**Re: Arizona Department of Environmental Quality 401 Certification for Rosemont
Copper, Public Notice 27-14AZ LTF 55425**

Additional Comments on State 401 Certification Decision – Rosemont Copper Project ACOE Application No. SPL – 2008-00816-MB

Evan Canfield and Akitsu Kimoto, Pima County Regional Flood Control District, and
Brian Powell and Julia Fonseca, Pima County Office of Sustainability and Conservation

FIGURE 8. GRAPH OF DEUTERIUM VERSUS DELTA OXYGEN-18 FROM WELLS, SPRINGS, AND SURFACE WATER LOCATIONS, APRIL THROUGH OCTOBER 2008, ROSEMONT AREA

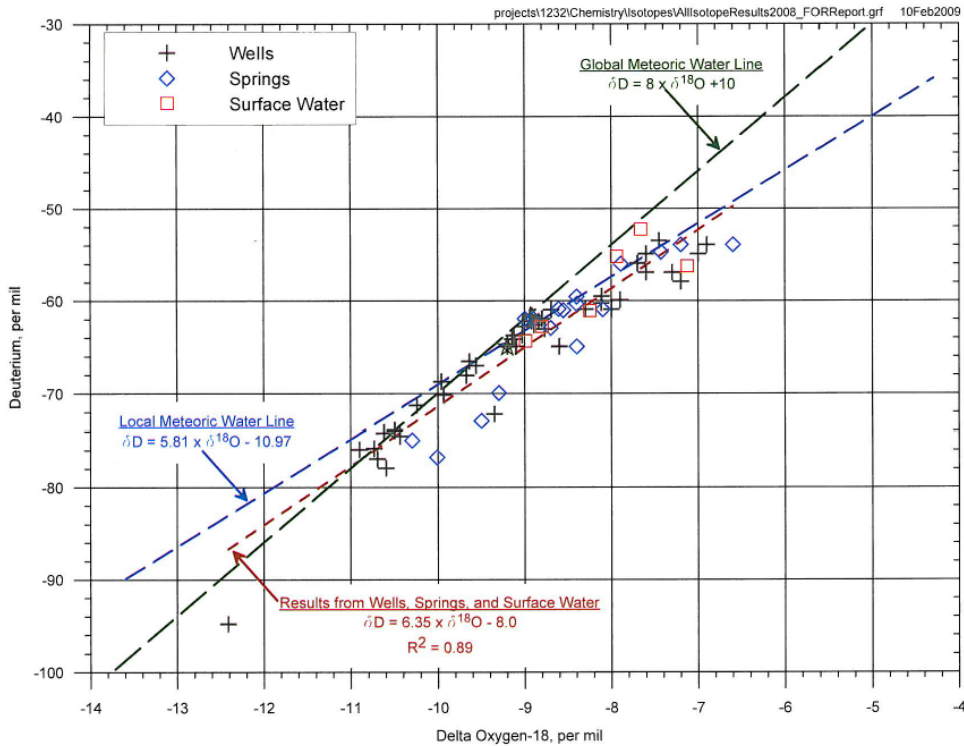
This is also shown graphically on Figure 8, Graph of Deuterium Versus Delta Oxygen-18 from Wells, Springs, and Surface Water Locations, April through October 2008, Rosemont Area (Montgomery and Associates, 2009). This figure is reproduced below. Wells are crosses. Note that the well delta oxygen values range from -12 to -7 on the horizontal scale. Note also that range of values for springs (diamonds) occupies nearly the same range, excepting the singular well value at RP-4B, which is a deep well screened in the Apache Canyon Formation.

4. Referencing Montgomery's Figure 8 again, note that all of the samples, even the PC wells, plotted below the Global Meteoric Water Line. This is not disclosed by Tetra Tech, and in fact the Tetra Tech plot actually obscures this fact by plotting a dashed line that does not represent the Global Meteoric Water Line. It can be seen that the intercept of Tetra Tech's line is much lower than the Global Meteoric Water Line that Montgomery shows. The slope of the local data, and the values of the PC wells considered as a group *both show substantial influence from natural evaporation during precipitation, runoff and / or recharge*, as was noted by Montgomery and Associates in their 2009 report. Tetra Tech did not discuss Montgomery's observation of an evaporative effect, presumably because it did not fit their preferred interpretation.

6. Figure 8 (Montgomery and Associates 2009) also has a local meteoric water line (LMWL) derived from data provided by Dr. Chris Eastoe. In attachment 3, Dr. Eastoe presents a more robust dataset for a LMWL. LMWL's are important because they provide a basis for interpreting sample results.

Figure 17
 Stable isotopes in Rosemont project site ground- and surface water

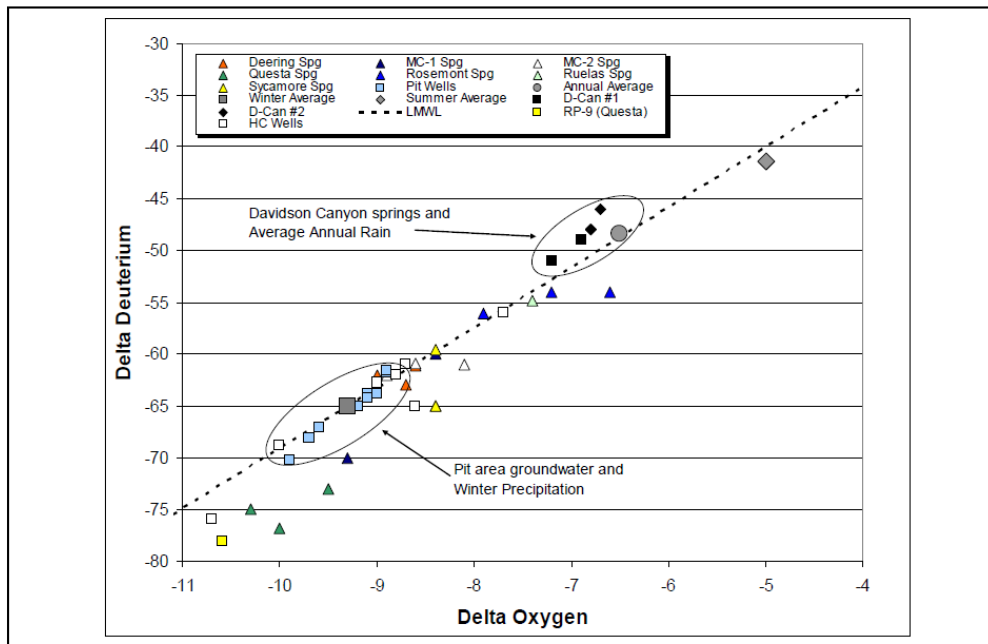
Some of these same data are shown on Figure 17 from Tetra Tech (2010), which differentiates the pit area groundwater (primarily PC well series) from other wells and springs in the mine vicinity. While it is true that the pit well data are largely grouped in the lighter oxygen values, many of Montgomery's other well and surface water data plot right along the red line calculated by Montgomery using the entire data set, suggesting that they are from the same population.

5. Tetra Tech's Figure 17 includes a data point representing winter average rainfall. This value is important because it is the principal basis for the inference that the position of the "*pit area groundwater*" on figure 17 means that *winter precipitation* is the source of the groundwater for the PC wells. Tetra Tech says that the winter average value is based on "stable isotope data for local precipitation" by Wagner (2006). Page 124 of Wagner 2006 provided several years of precipitation data from the vicinity of Cave of the Bells, in the Santa Rita mountains farther south. There were too few years in Wagner's sample to define a local meteoric water line (Dr. Chris Eastoe, personal communication).

10. Tetra Tech omitted well data that did not support their hypothesis. Tetra Tech's Figure 17 omits many of the wells and spring samples that plotted closer to the PAG dataset, but retained the "pit wells" that favored Tetra Tech's interpretation. The omitted samples that plotted closer to the PAG data set included wells RP-4A and RP-3A located in areas under the waste rock and tailings landform, and Rosemont spring, which would also be covered with waste rock and tailings.

FIGURE 8. GRAPH OF DEUTERIUM VERSUS DELTA OXYGEN-18 FROM WELLS, SPRINGS, AND SURFACE WATER LOCATIONS, APRIL THROUGH OCTOBER 2008, ROSEMONT AREA

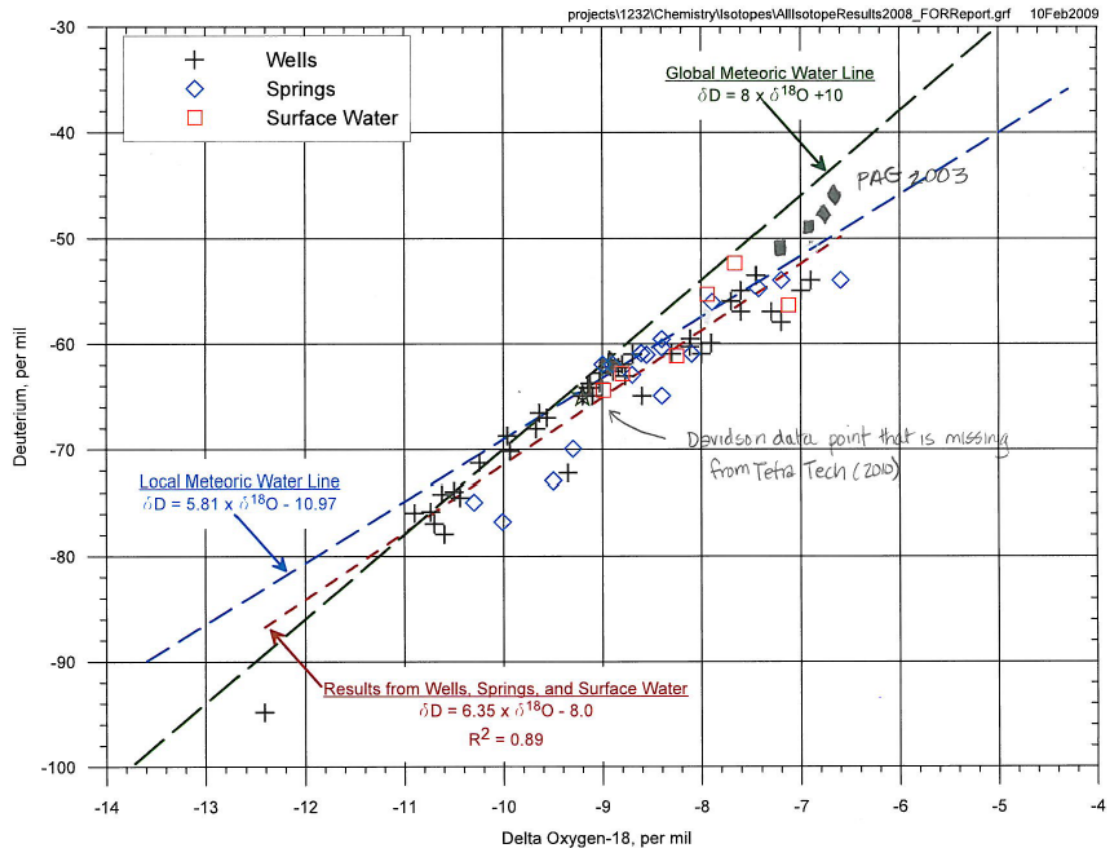
12. Turning now to the Davidson surface flows, Tetra Tech fails to plot or discuss the sample results shown on Montgomery's Table 12 for lower Davidson Canyon Wash. **This sample has a $\delta^{18}\text{O}$ value equal to -9.** This is similar to the pit wells and the so-called winter precipitation. Thus, Tetra Tech's interpretation regarding the character of Davidson spring **is not supported by the only sample which was contemporaneous with the well data to which it is compared.** No explanation is offered in the Tetra Tech report for this omission.

PAG 2003 DATA
PLOTTED BY HAND
